STAFF RECOMMENDATION

700 B Shelby Avenue

Application: New Construction—Infill

Description of Project: Construct detached infill behind existing non-contributing house.

① SCHEMATIC SITE PLAN
1" = 20'-0"

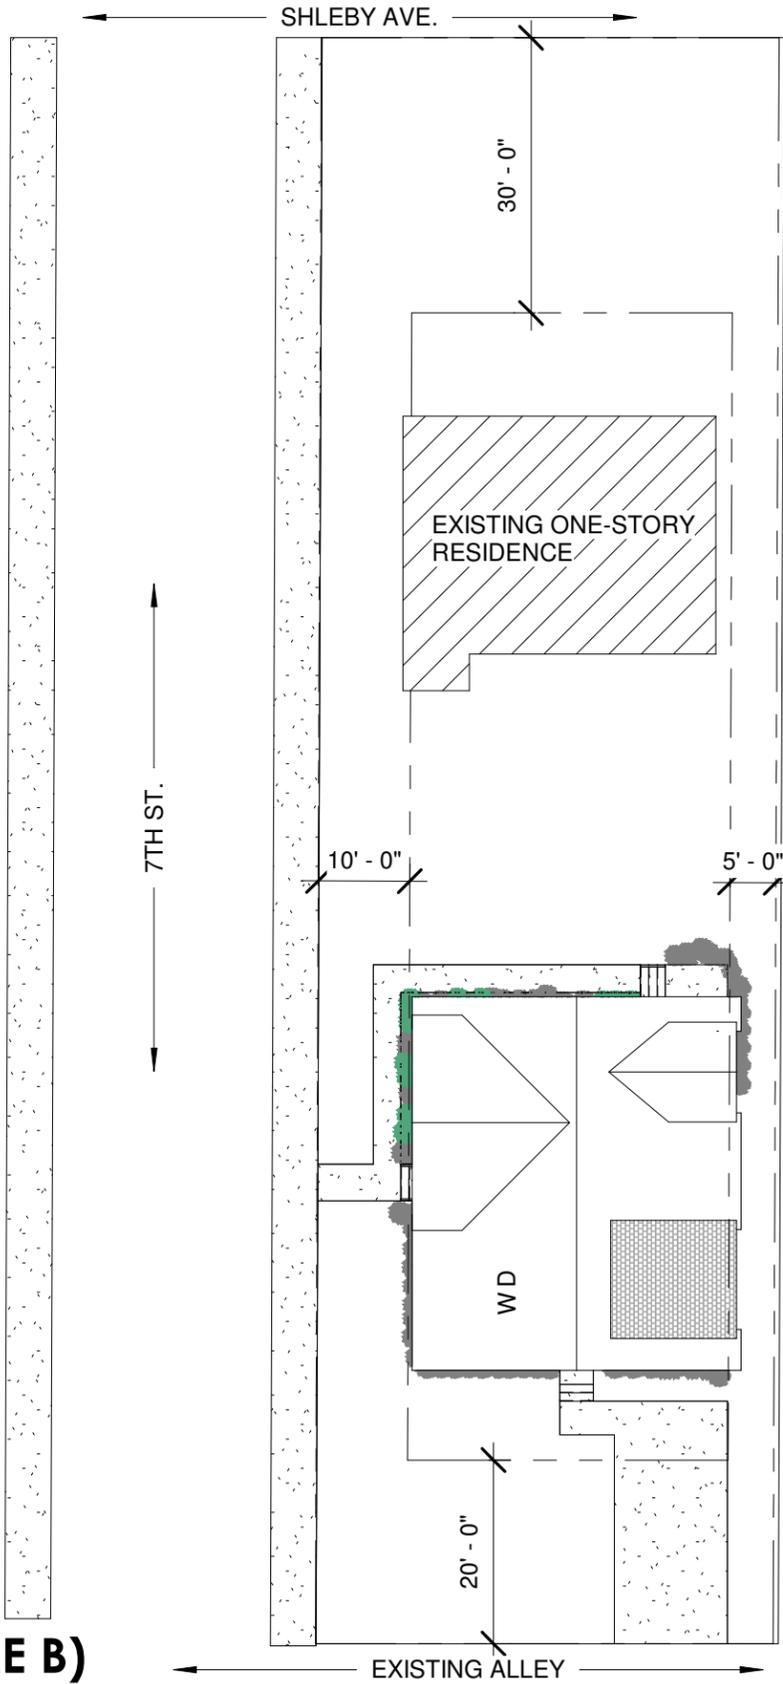
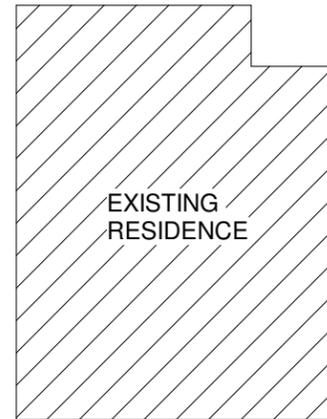
Setback & Rhythm of Spacing: While the proposal meets all base zoning setbacks, staff finds that it does not meet the conditions in which a detached dwelling could be appropriate in the Edgefield Historic Preservation Zoning Overlay. Section III.B.2.a of the Edgefield design guidelines states that a detached dwelling can be appropriate in the following instances:

The subject property is fifty feet (50’) wide by one hundred seventy-five feet (175’) deep, which is typical for the 700 block of Shelby Avenue. The base zoning is R8, and the lot area is eight thousand seven hundred fifty square feet (8750 sq. ft.). The width and area of the lot cannot accommodate two single-family dwellings in a way that meets the design guidelines and is compatible with the historic context.

The proposed detached structure also does not meet the requirements for a DADU as it exceeds the maximums for ridge and eave heights, footprint, and living area, and the dormers do not meet the design standards as they are wall dormers.

Finally, the existing house does not sit far back on the lot, and the proposed infill is located behind the principal structure.

For these reasons, staff finds that the project does not meet Section III.B.2.a. for Setbacks and Rhythm of Spacing.

Orientation: The proposed infill is oriented to South 7th Street with a front porch that is approximately five feet (5') deep. While a secondary entrance on a fully attached duplex

would be appropriate, the infill's located approximately thirty-three feet (33') behind the existing principal structure with its primary orientation to South 7th Street is inappropriate for the historic context and does not meet the Edgefield design guidelines.

Appurtenances & Utilities: The location of the HVAC and other utilities as well as appurtenances such as fencing were not noted on the plan. Vehicular access is from the alley, and an uncovered parking pad is shown at the rear of the lot. While the project could meet Section III.B.2.i with conditions, staff finds that the overall project does not meet the Edgefield design guidelines.

① OVERALL ROOF PLAN
1/8" = 1'-0"

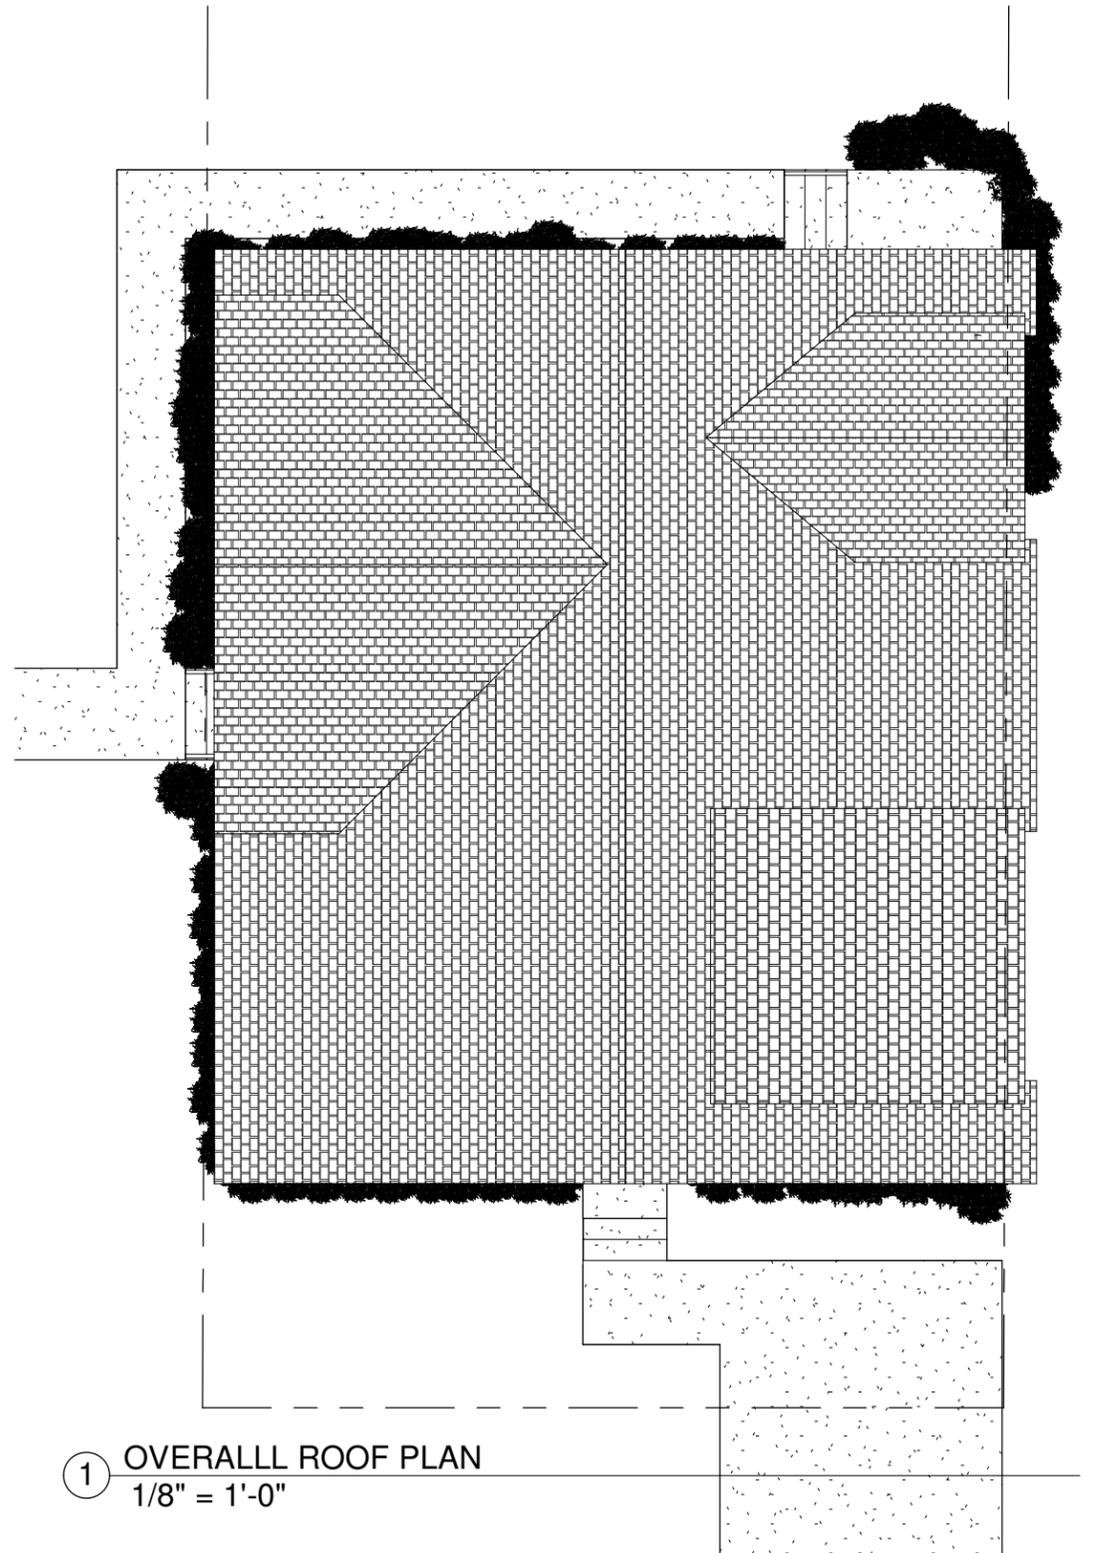
Roof form & Building Shape: The proposed structure is front gabled with a primary pitch of 10/12. Dormers are incorporated on both side façades. As proposed, all of the dormers are wall dormers that stack on the wall below. This does not meet the design guidelines which require that dormers be set in two feet (2') from the wall below. The dormer facing South 7th Street has a gabled roof form with a 10/12 pitch and incorporates a balcony that is located fully under roof. The interior side elevation incorporates two dormers. One of the dormers has a shed roof form with a pitch of 4/12 while the other dormer is gabled with a 12/12 pitch.

The project does not meet Sections III.B.2.c and d.

① FRONT ELEVATION
1/4" = 1'-0"

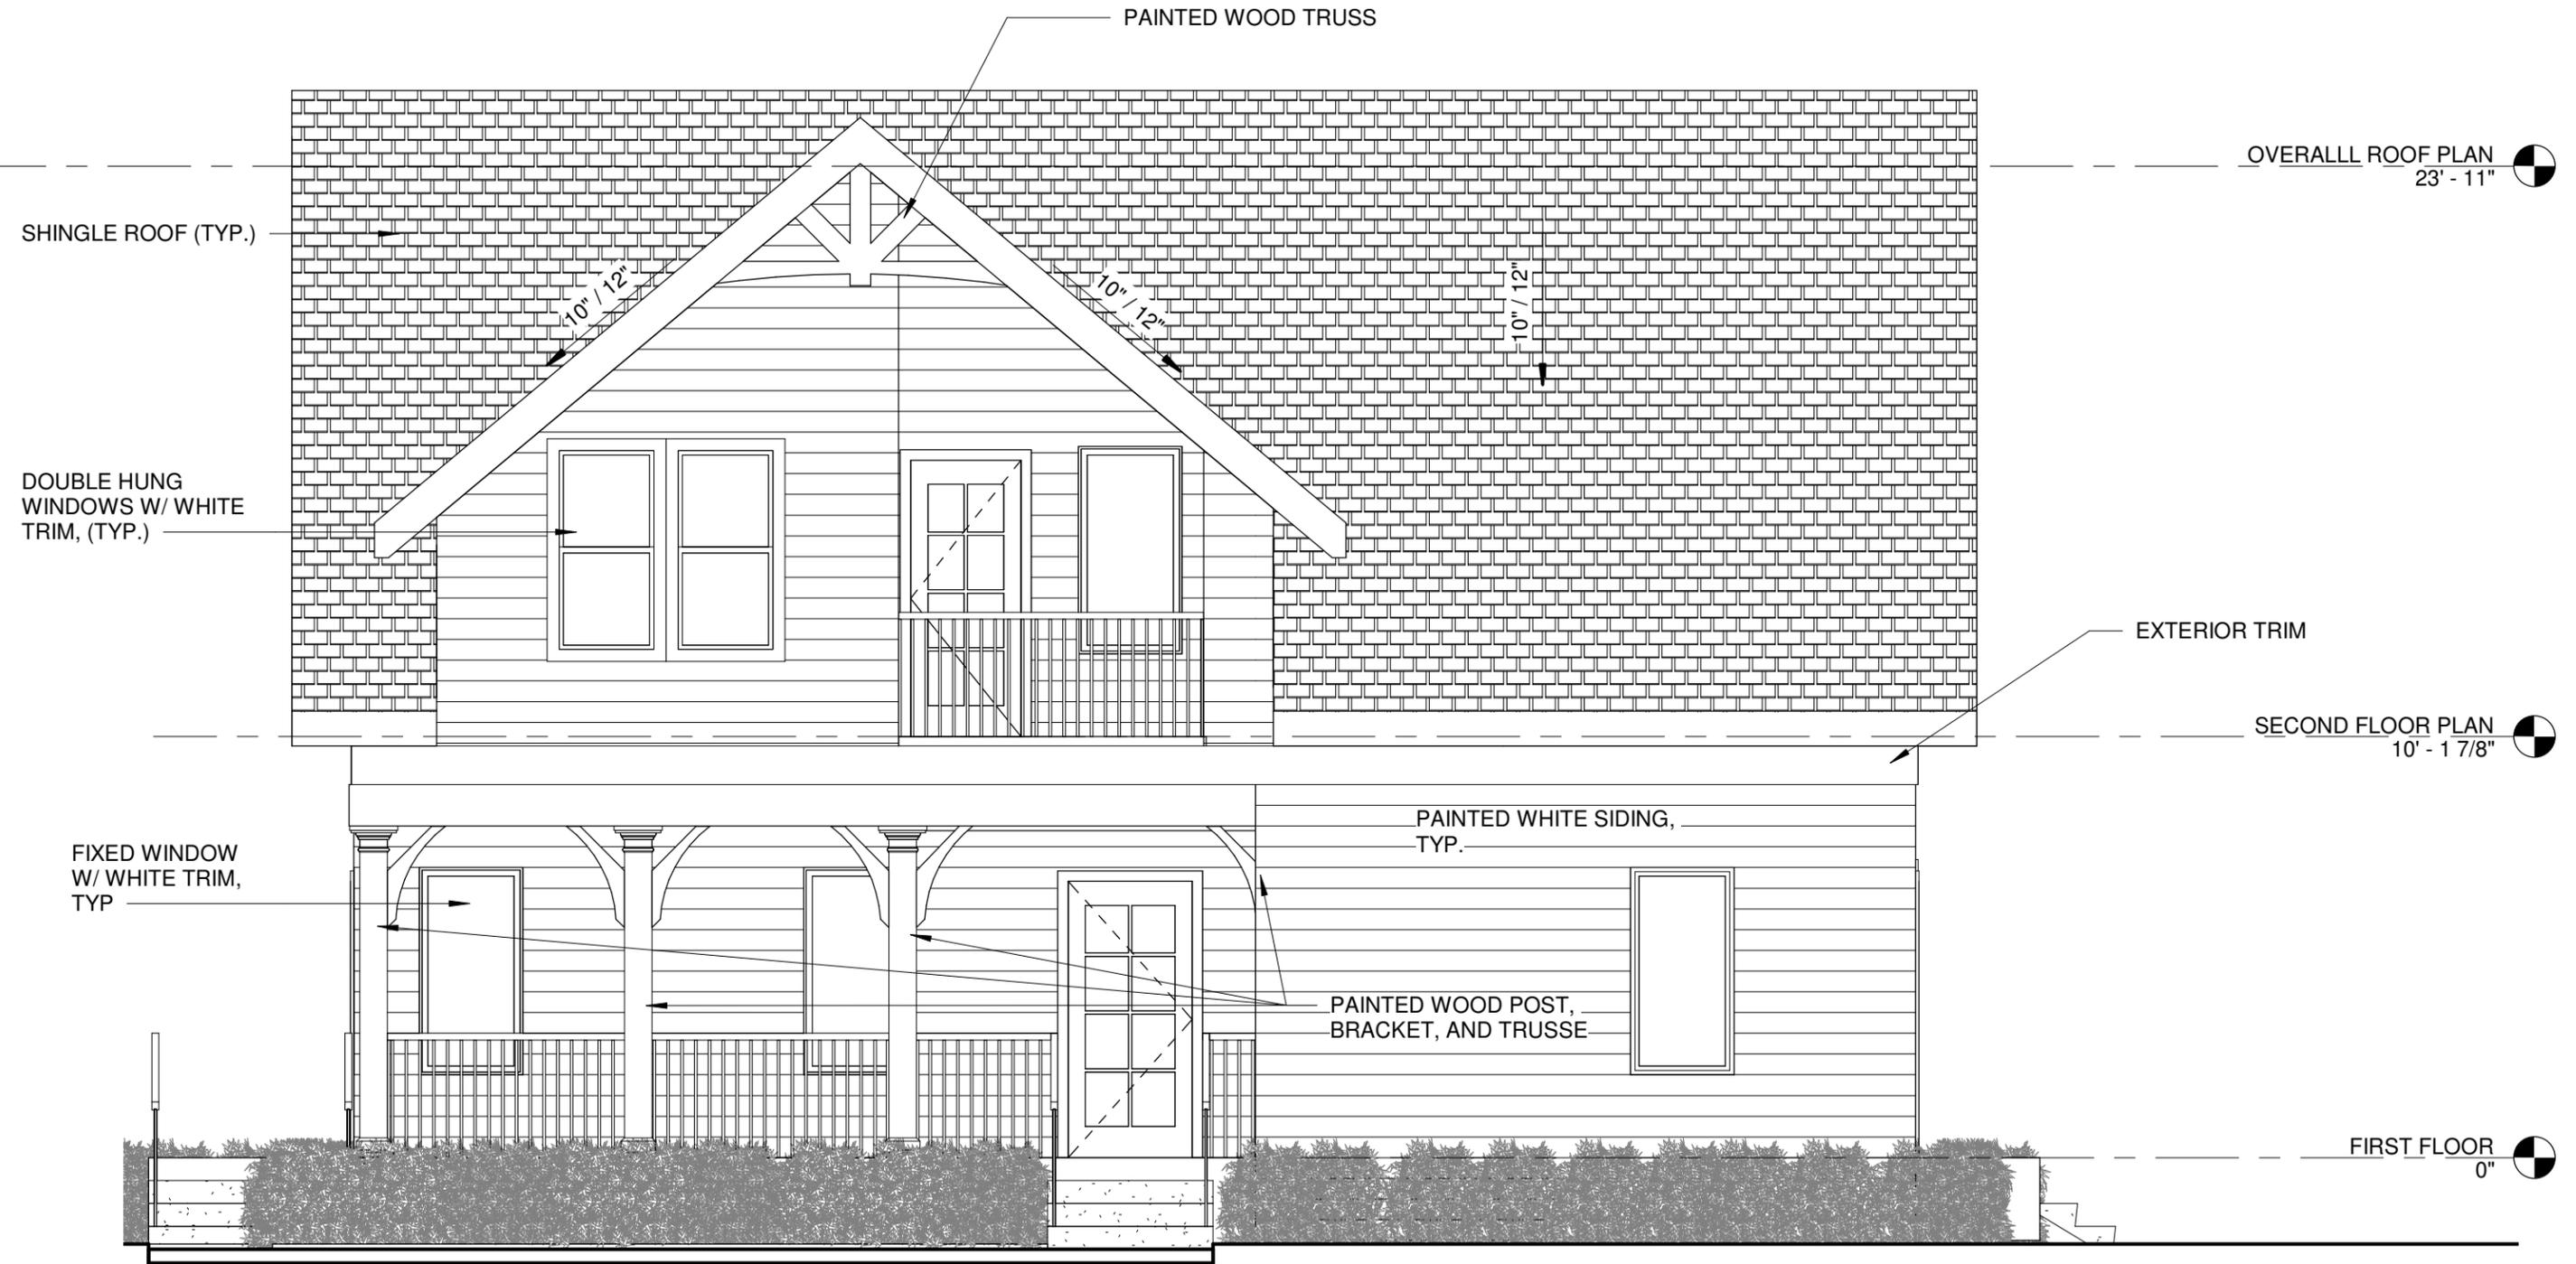
Height & Scale: The detached structure has a one and one-half story form with a ridge height of twenty-eight feet (28’) from grade and twelve-foot (12’) eaves measured from grade. The structure is approximately thirty-one feet (31’) wide. While the one and one-half story form as well as the height and width could be appropriate for infill, the location of the infill at the rear of the lot does not meet the design guidelines. In addition, the height and scale of the proposed infill overwhelms that of the existing non-contributing house at the front of the lot, which is one-story and approximately fourteen feet (14’) tall.

The project does not meet Sections III.B.2.a and b.

① LEFT ELEVATION
1/4" = 1'-0"

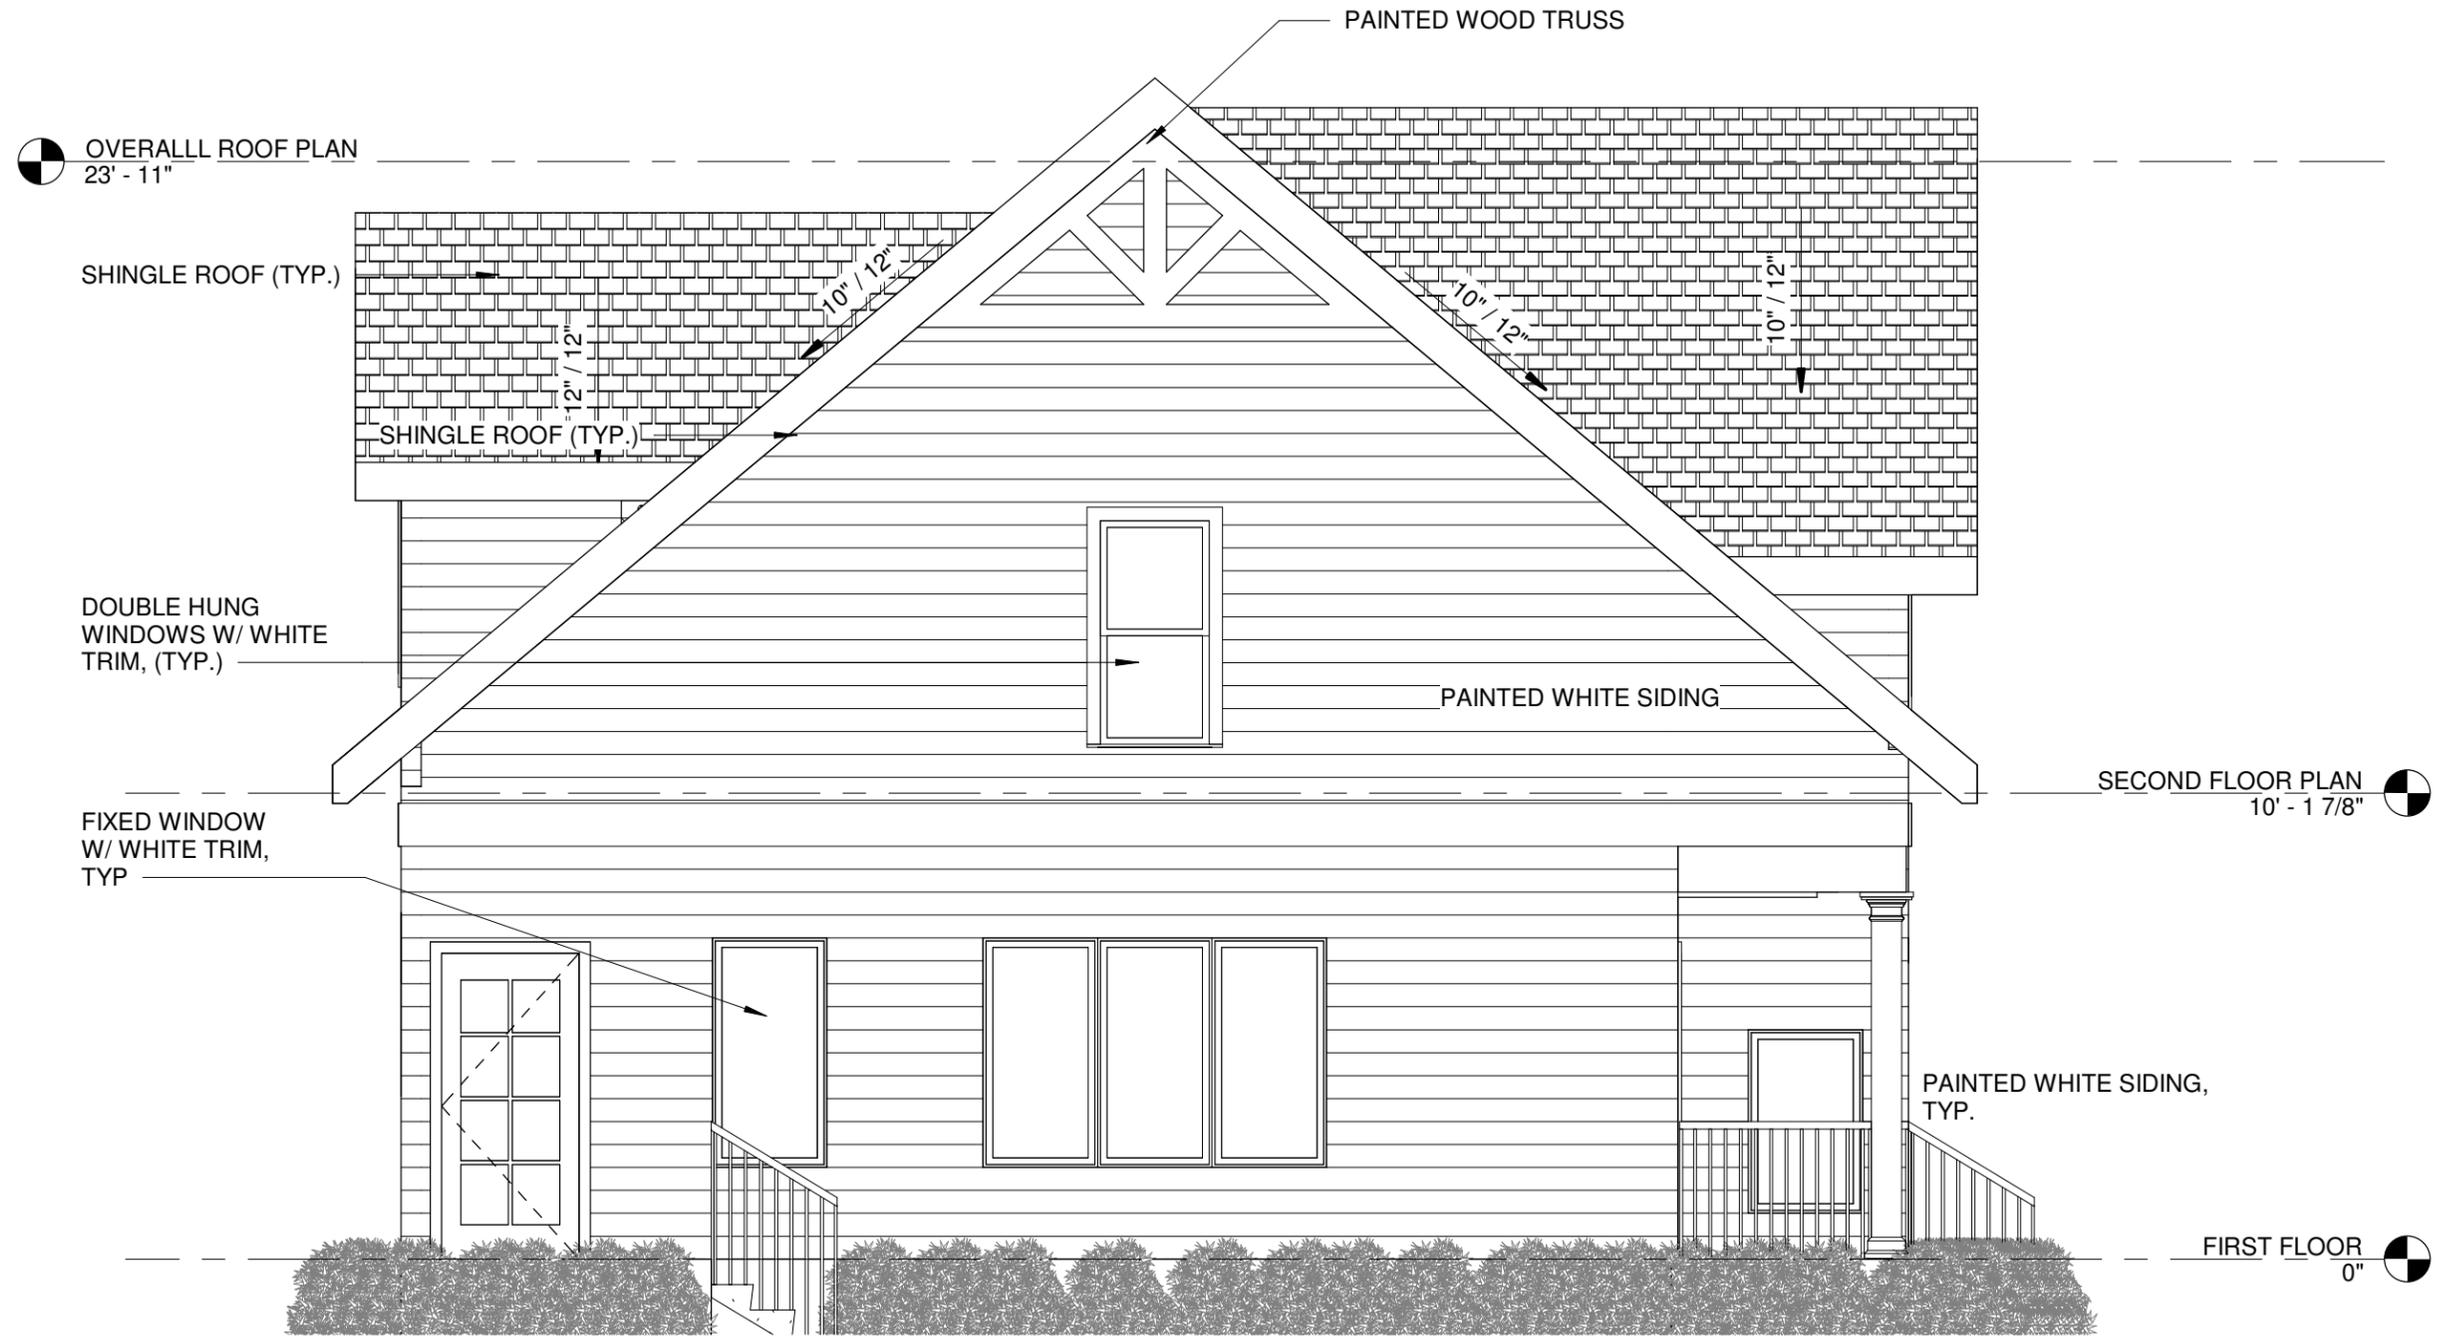
Many of the details of the materials are unknown at this time. In addition, the elevations do not incorporate corner boards at the face of each exposed corner. While the project could meet Section III.B.2.g with conditions, staff finds that the overall project does not meet the Edgefield design guidelines.

Proportion and Rhythm of Openings: Most of the windows on the proposed structure are all generally twice as tall as they are wide, thereby meeting the historic proportions of openings. There are two small horizontal windows on the left-side façade that do not meet the design guidelines. Also, there are no large expanses of wall space without a window or door opening.

Staff finds the project's proportion and rhythm of openings do not meet Section III.B.2.f.
